**CITY OF HANOVER  
PLANNING COMMISSION MEETING  
JULY 27, 2020  
AGENDA  
VIA ZOOM (VIRTUAL MEETING)**

**SUBJECT:** **River's Edge of Hanover** for Concept Plan

**Re:** *River's Edge of Hanover Concept Plan Review*

**Re:** *Hilltop Renovation Plan Submittal Review  
WSB Project No. 016500-000*

PRELIMINARY LOT CONFIGURATIONS

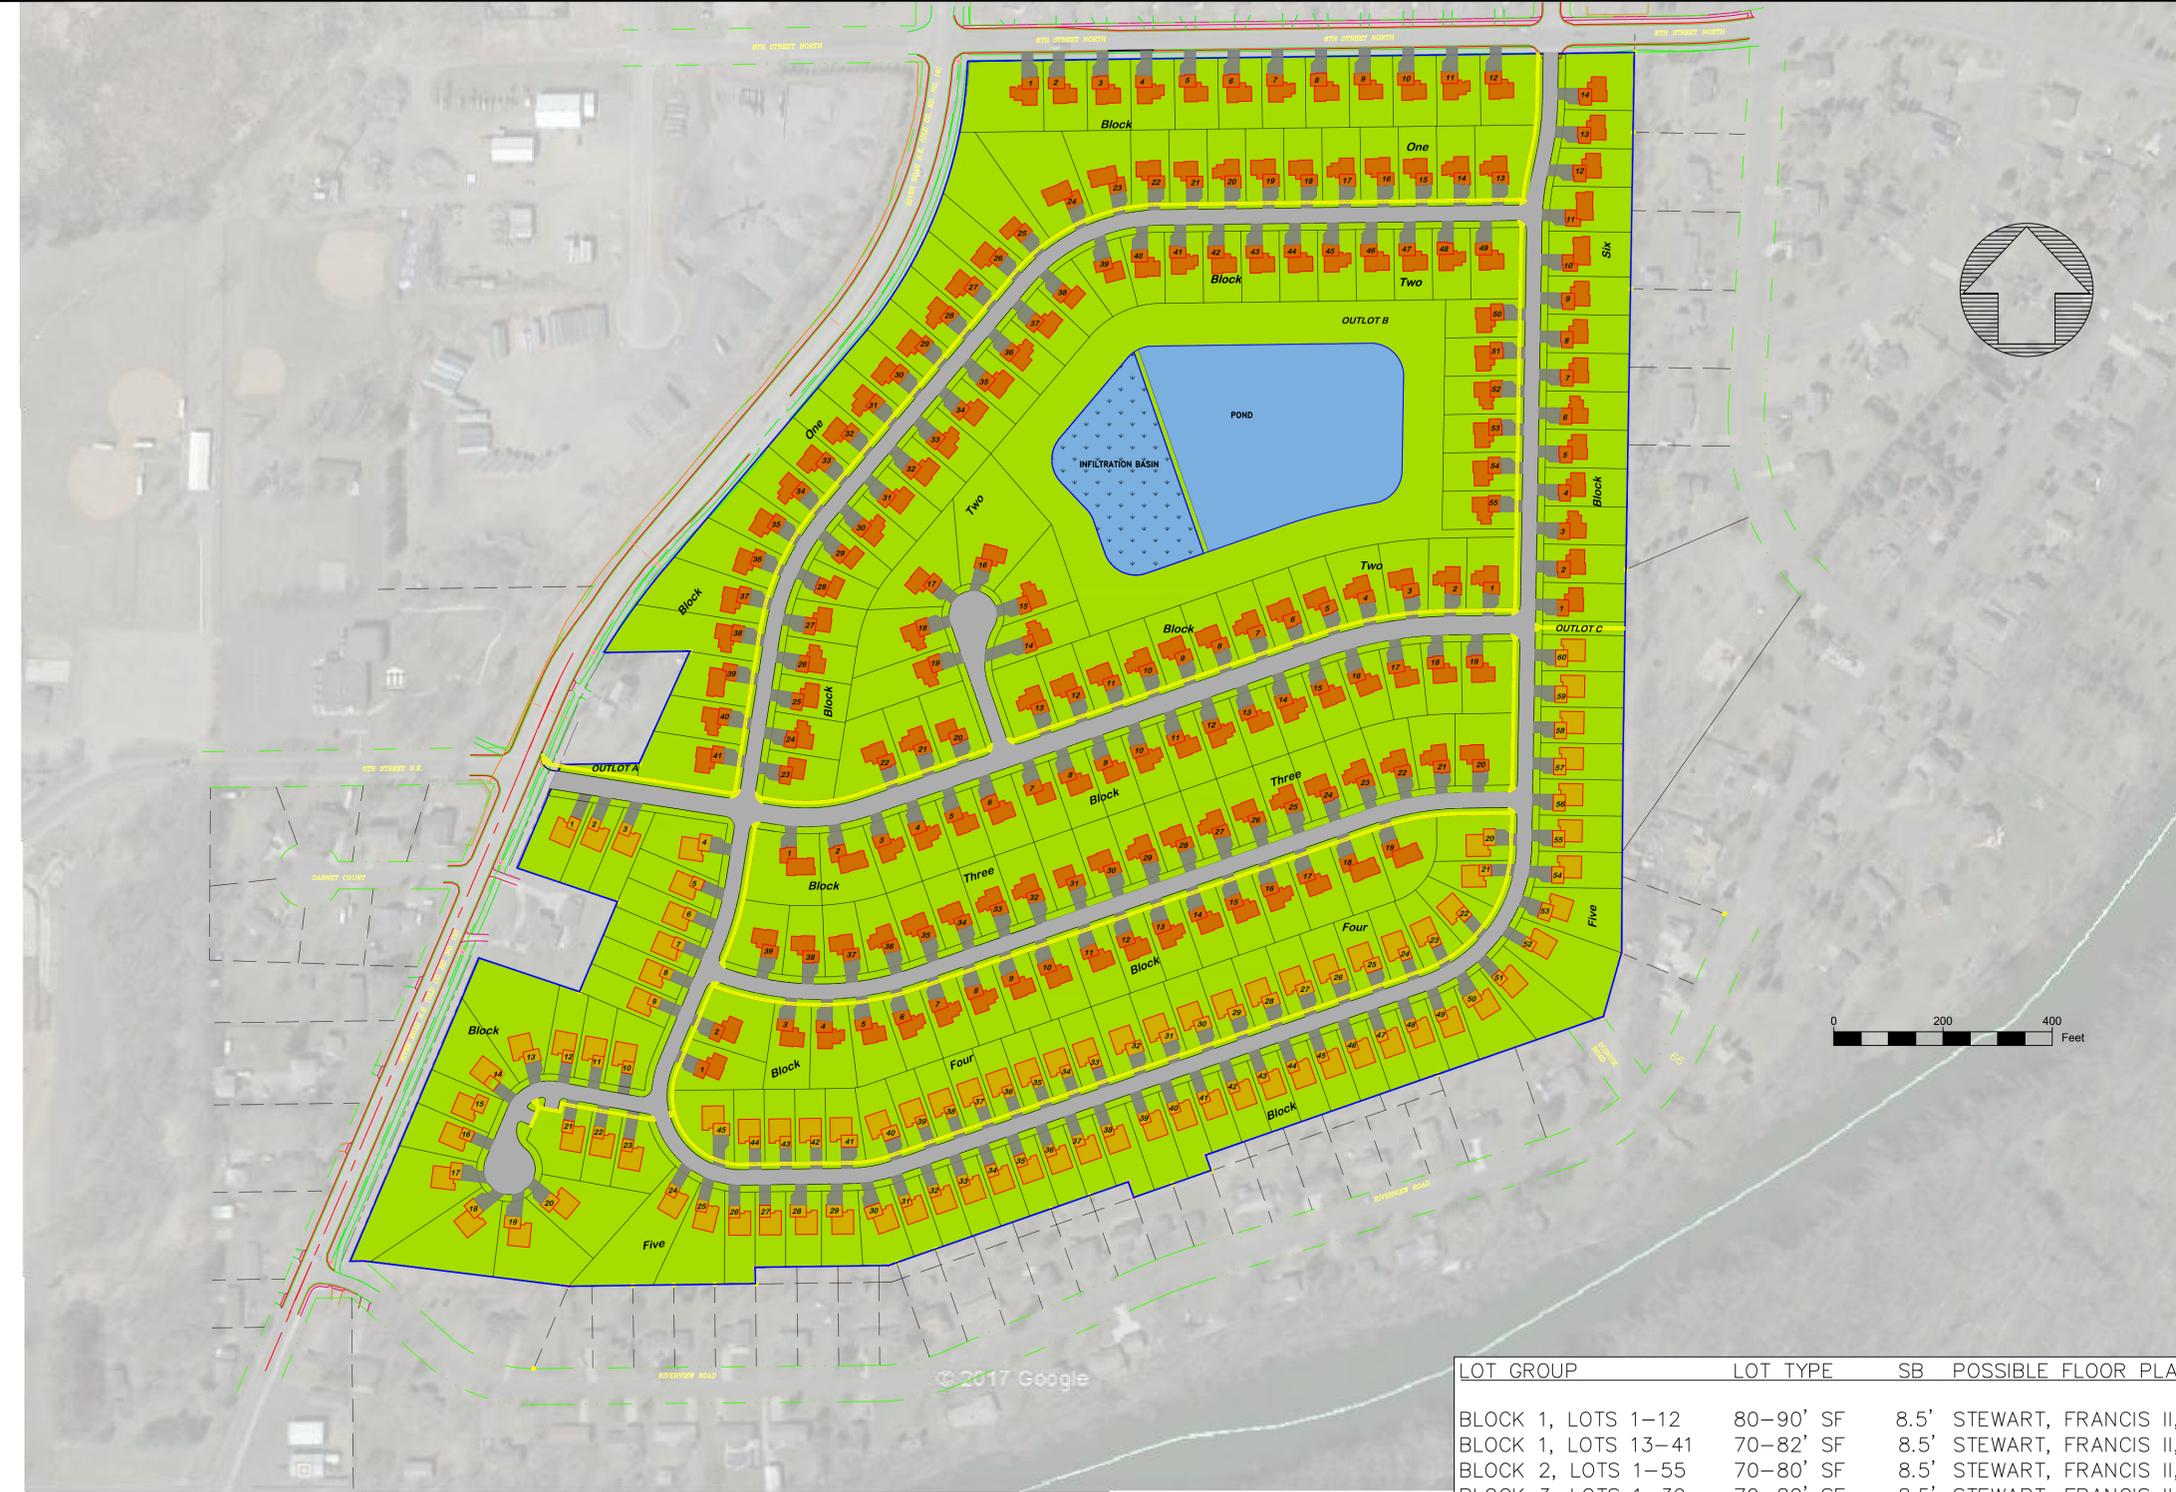
I have reviewed the concept plan dated July 20, 2020 and offer the following comments:

1. Single-family homes – A Planned Unit Development is required for amendments to lot size, setbacks, and lot width.
2. Villas may only be permitted under a PUD when the property is in the R-1 district. The proposed villa homes appear to meet the standards prescribed in the R-2 zoning district for villas.
3. The concept plan appears to meet the setbacks of the underlying zoning district on the perimeter of the site.
4. The lots adjacent to 8<sup>th</sup> Street are shown at 80 feet wide which is consistent with the lots on the north side of 8<sup>th</sup> Street.
5. Recommend the 3 lots at the entrance of the neighborhood across from Outlot A be removed to reduce conflicts with traffic entering/existing the neighborhood.

6. The site appears to meet the density requirements of the Comprehensive Plan (2 to 4 units per net developable acre). Ponding and the right of way for River Road must be excluded from the gross area of the site for the calculation. This would be reviewed more fully at preliminary plat.
7. Identify use and ownership of Outlot A.
8. A Homeowner's Association will be required, and association documents will be required to be provided to the City for review and approval with the Final Plat submittal.

9. The City's Comprehensive Plan does not identify a need for additional park land in this location. Park dedication would be payment-in-lieu of land.
10. Architectural requirements would be a part of a PUD approval.
11. No overhead utilities would be permitted.
12. A landscape and tree preservation plan would be required to be submitted with the preliminary plat.
13. Sidewalks required on one side of every street.

PROJECT NUMBER: C20-0001  
**SHEET: C1**  
**SITE PLAN**

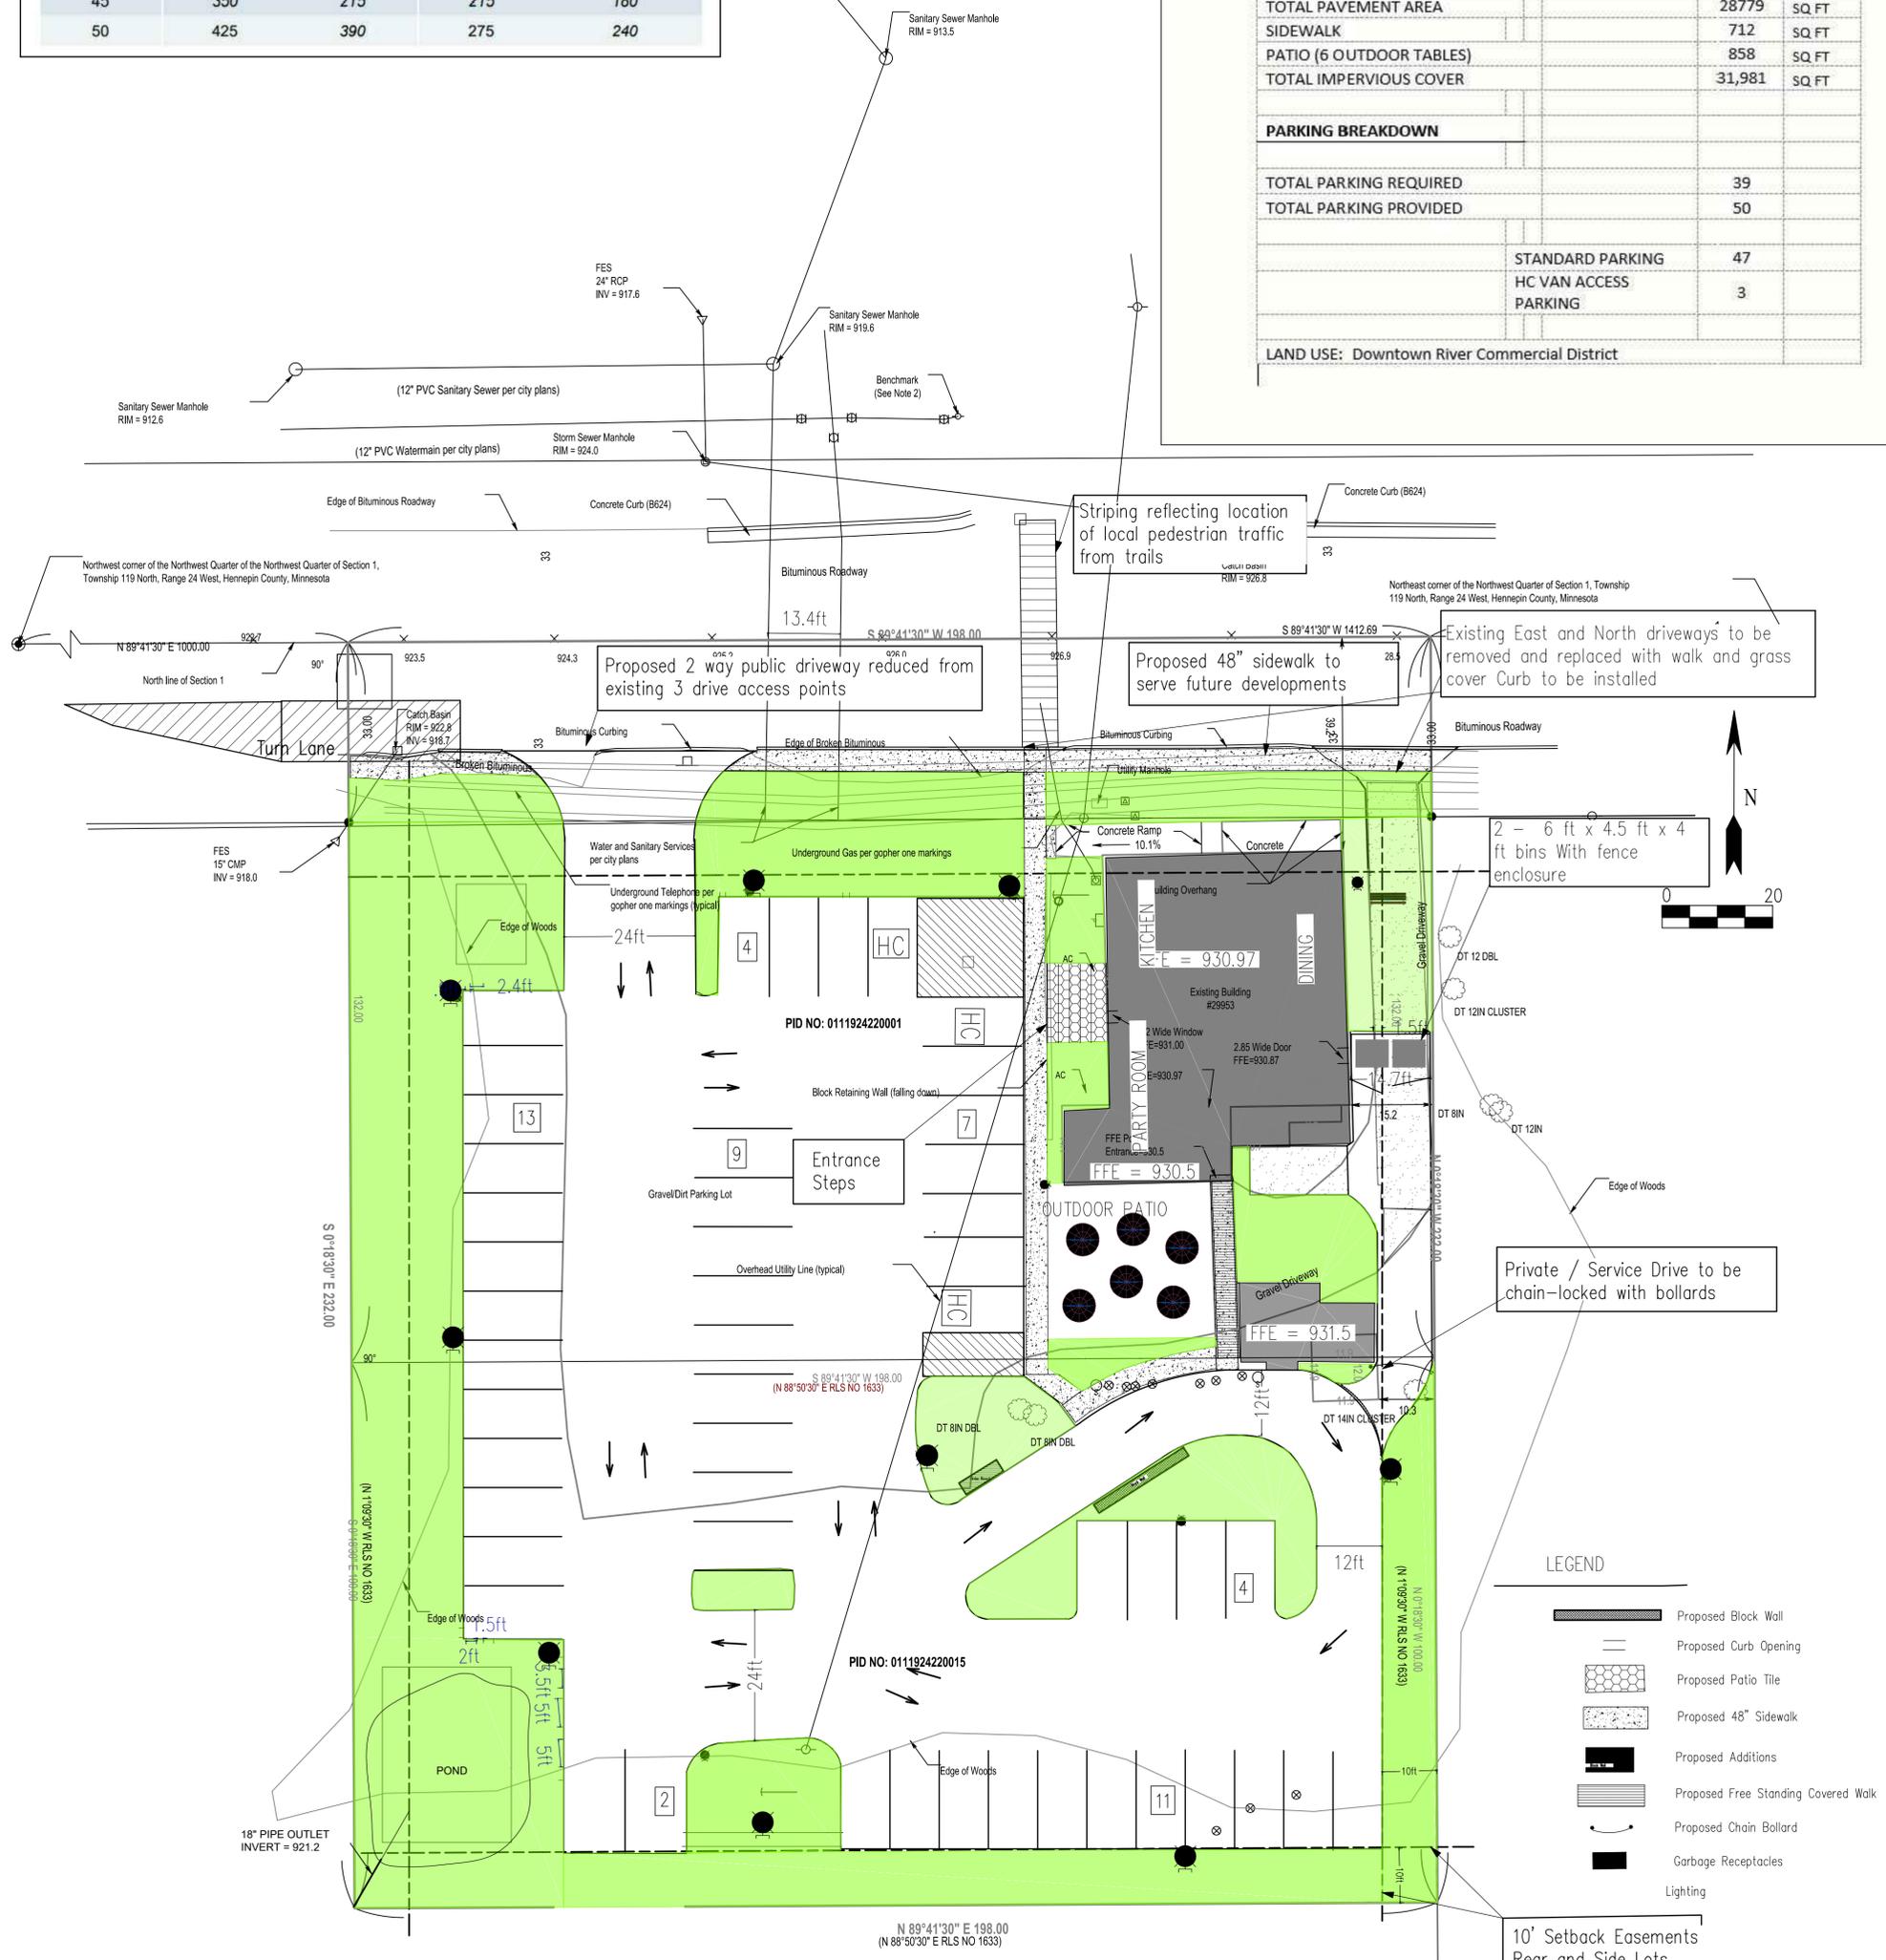
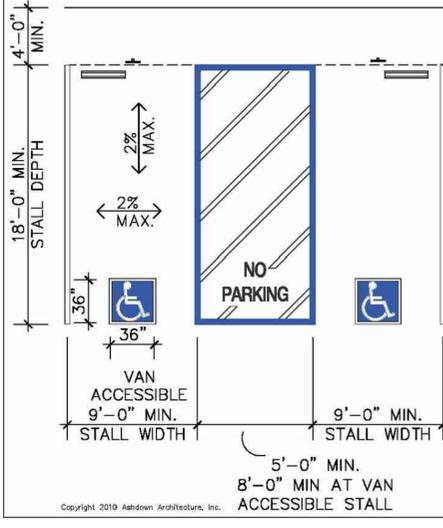
1. Symbology used throughout the drawing should be shown in the legend (Example: lights).
2. Add lighting and photometric plans to the documents.
3. Label turn lane dimensions (width, storage length, taper).

4. Label remaining thru lane width after turn lane is added.
5. Remove the crosswalk across CSAH 19 from the plans.
6. Concrete ramp slope adjacent to the building (10.1%) exceeds the maximum slope allowed for ADA.

7. Clarify whether curb will be installed along the perimeter of the parking lot. If curb is not proposed, provisions such as parking blocks or guard rail will be required to provide protection adjacent to the ravine on the westerly property line.

8. Specify the proposed parking lot surface material. See *Section 10.39.A of the City's Zoning Ordinance*.
9. Show parking stall dimensions. See *Section 10.39.C.2 of the City's Zoning Ordinance*.
